LIGO PROJECT		designed for	R.De Salvo
		draw. by	G. Gennaro-PROMEC
		date	26-12-04
title		LIGO-D051103-04-D	
SECTION E-E		scale	1/6 A 1

section F

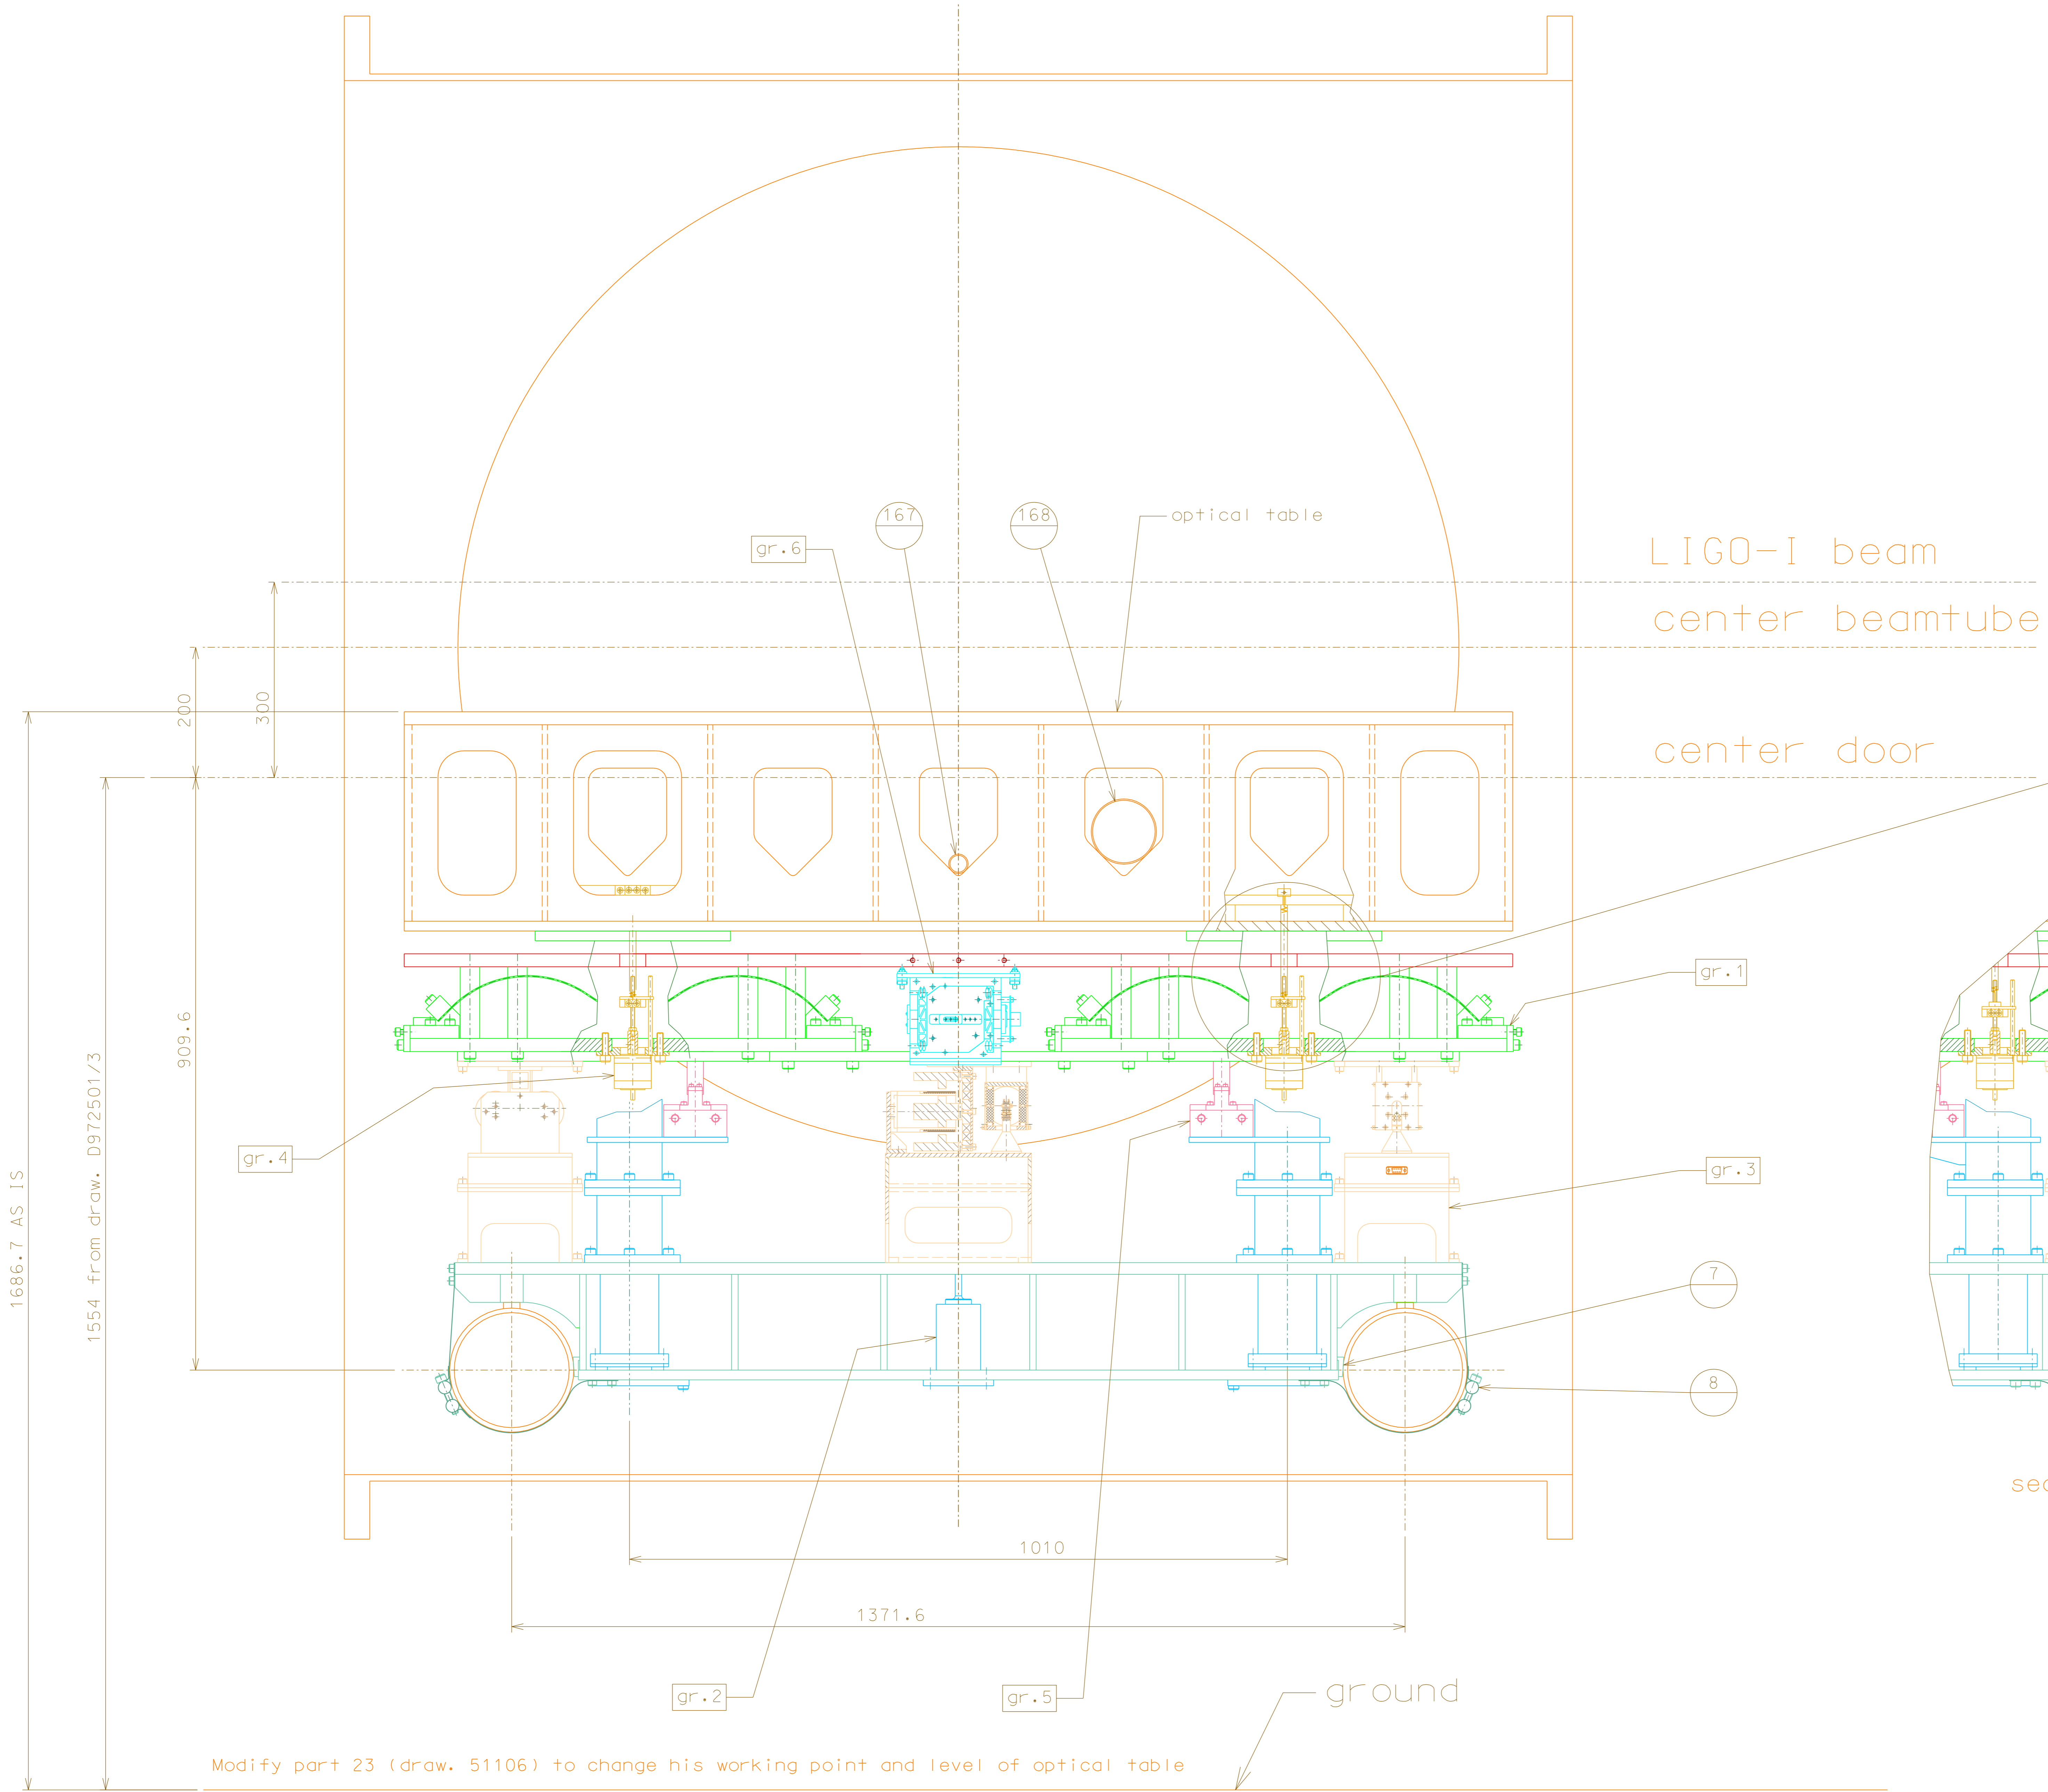
mounting the spring on new optical

Modify part 23 (draw. 51106) to change his working point and level of optical table
